**1.0 APPLICATION SUMMARY**

**Applicant:** John Falkner  
**FLU Category:** Residential - 4 (RES-4)  
**Service Area:** Urban  
**Site Acreage:** 8.99 MOL  
**Community Plan Area:** Wimauma  
**Overlay:** Wimauma Downtown Subdistrict C  
 – Downtown West

**Introduction Summary:**  
 The subject site is located within PD 89-0097 which consists of approximately 1,384 acres and multiple parcels. PD 89-0097 as most recently modified by MM 18-1052 is approved to allow for 4,228 dwelling units, 447,047 square feet of commercial development and 40,000 square feet of office development. If approved, a portion of Parcel A-1 would allow the commercial component to be permitted the same height threshold at 60' or 4 stories as the residential/multi-family permitted in Parcel A-1.

TO: Zoning Technician, Development Services Department  
REVIEWER: Alex Steady, Senior Planner  
PLANNING AREA/SECTOR: Wimauma/ South

231-Lighting

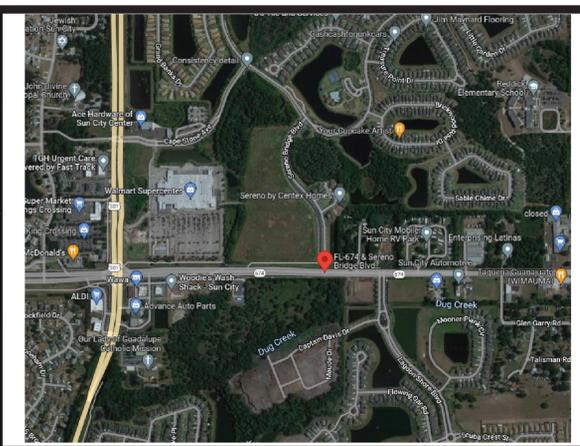
Lighting of sidewalks and/or shared paths must be to current standards (FDM section 231). Newly implemented FDOT Context classifications updated the required sidewalk widths (FDM section 222.2.1.1). Where sidewalk is being added and/or widened, the lighting will be analyzed to ensure sidewalks are properly lighted per FDOT FDM standards. Reference the following link and table for details:

SHEET CONTENTS:  
Preliminary  
Site Plan

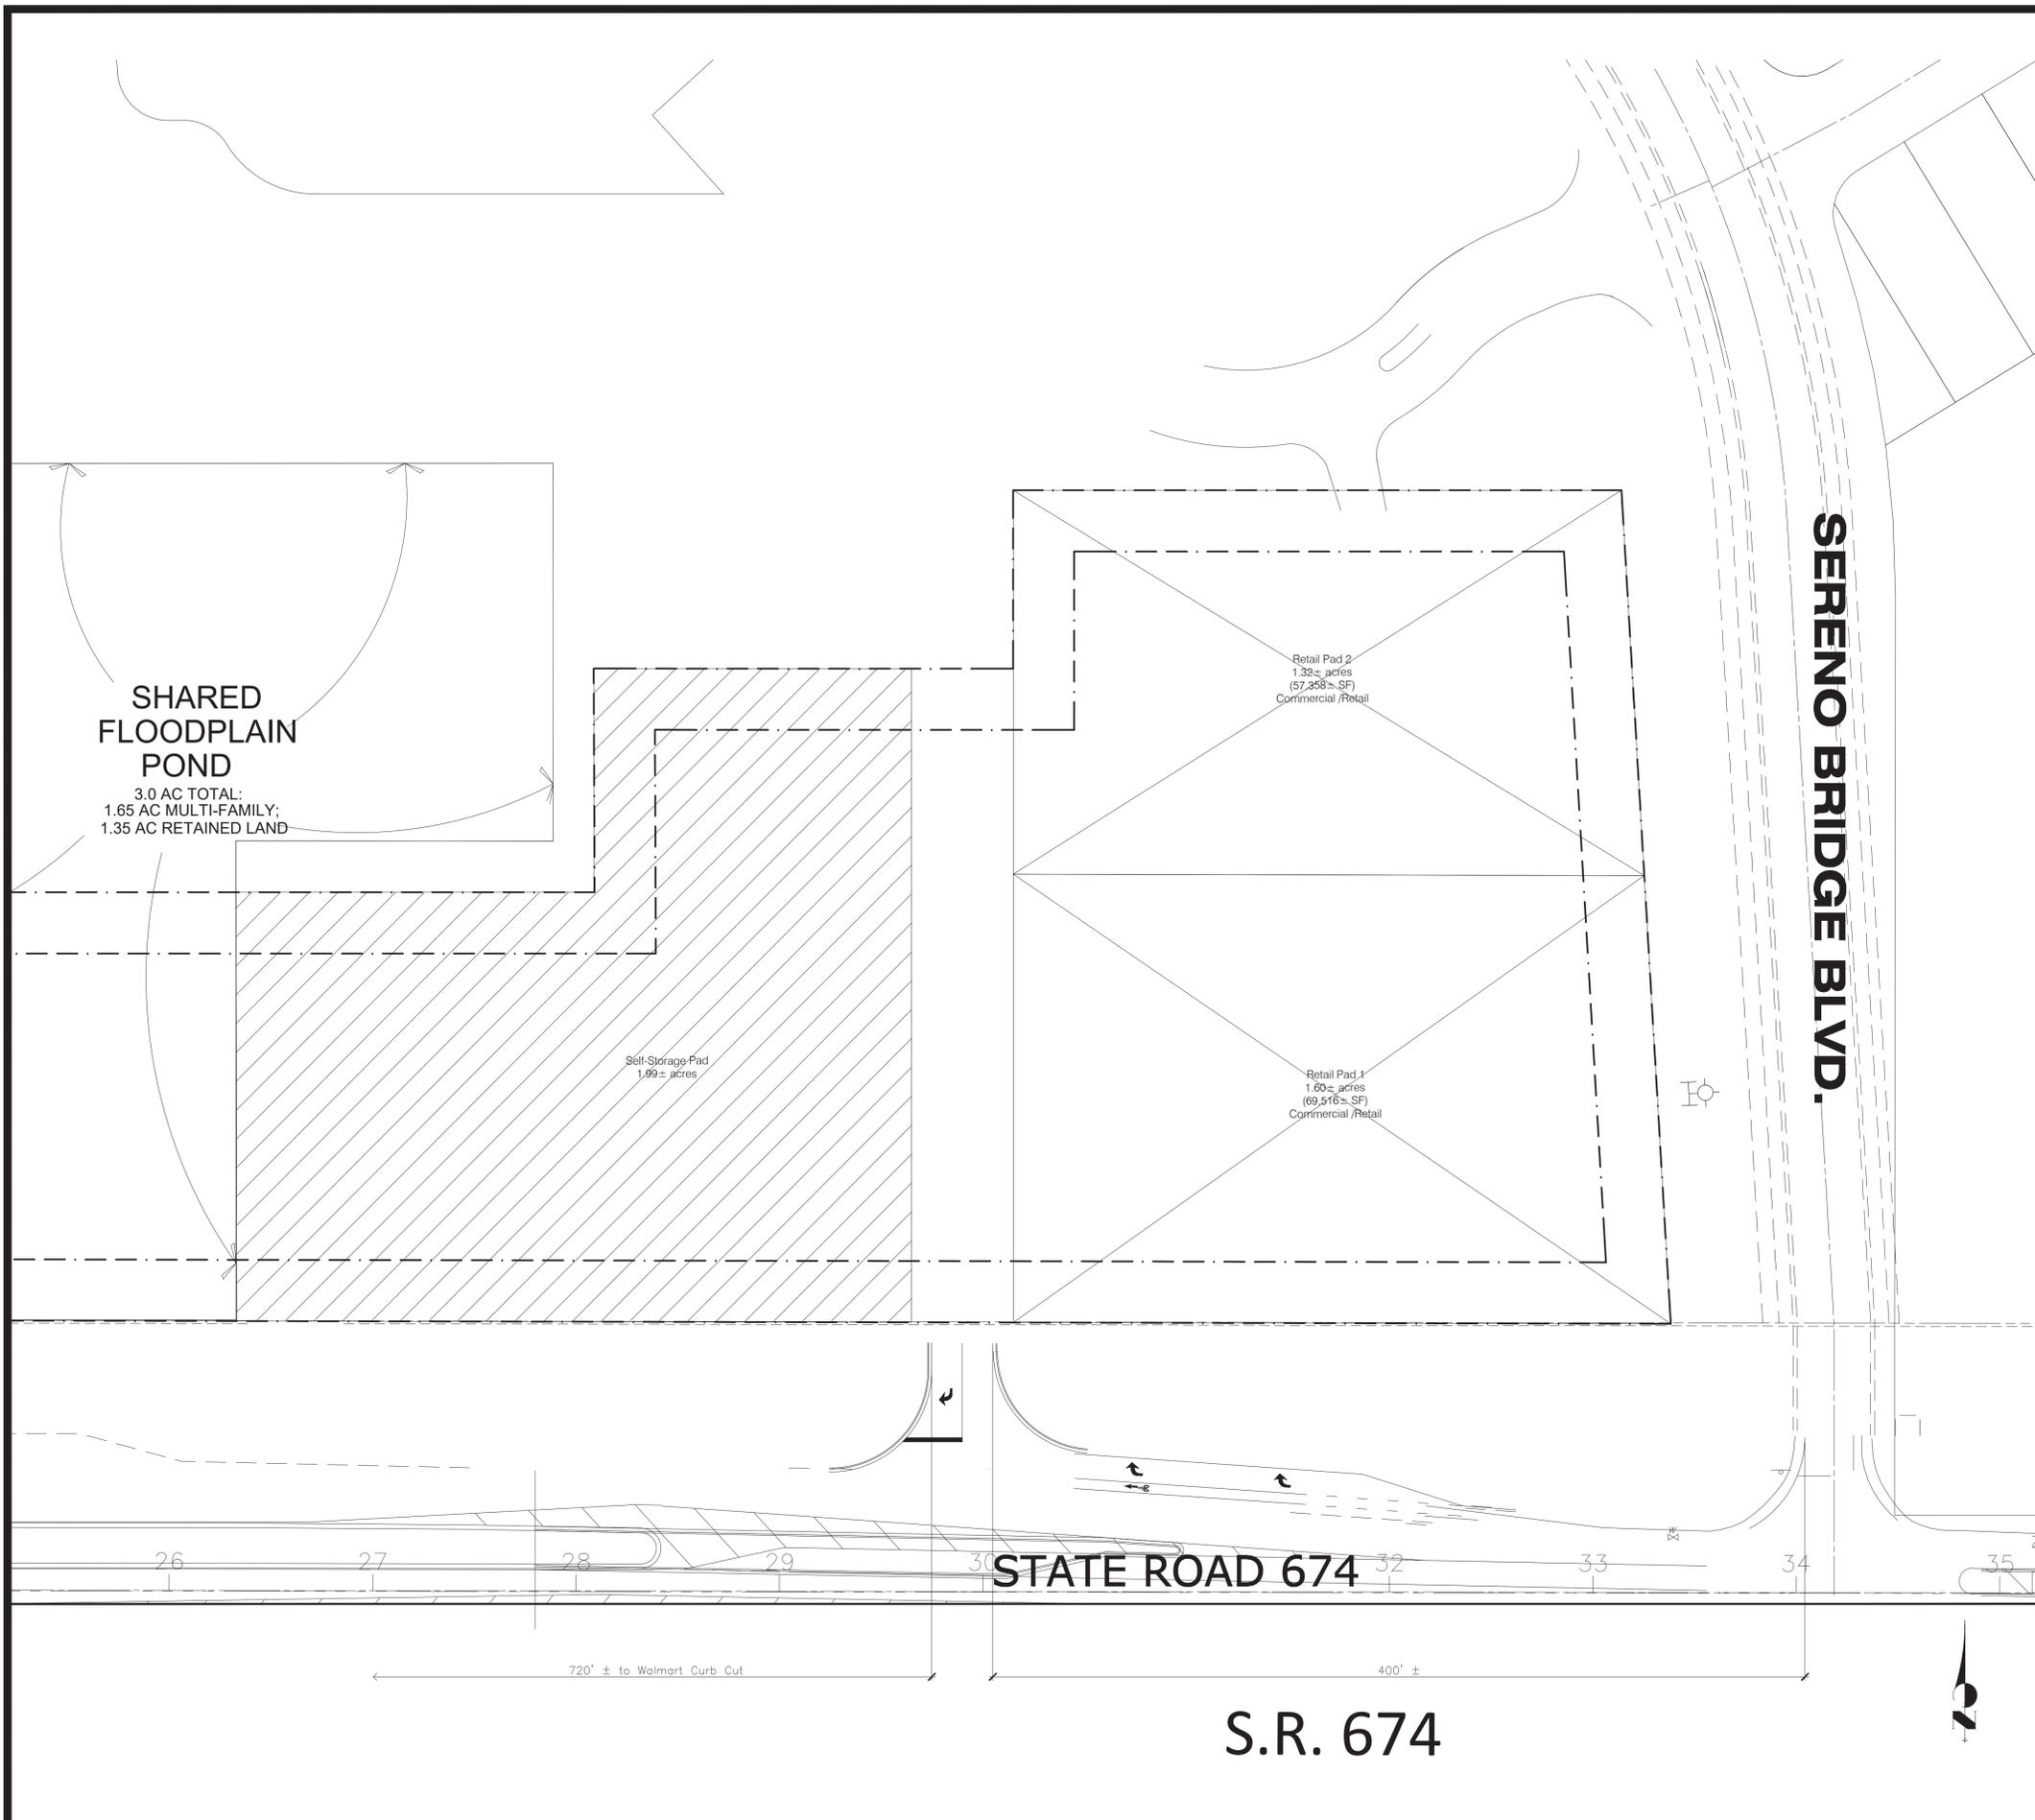
1. 1 Access to SR 674 Rt. In/Out as proposed, Sidewalk connection to FDOT sidewalk.
2. Traffic Study required, W/B Rt. Turn Lane with median nose modification as discussed.

3. Cross Access to side streets to the West and East.
4. When ready to permit follow the Rule Chapter 14-96.005 Application. Check List Attachment for reference. Please apply on line. <http://osp.fdot.gov> Attach a copy of this letter in submittal. Please include project "Name" in EOR name section on application. Plans shall be per FDM/PPM. All Plans and Documents shall be electronically signed and sealed in OSP.
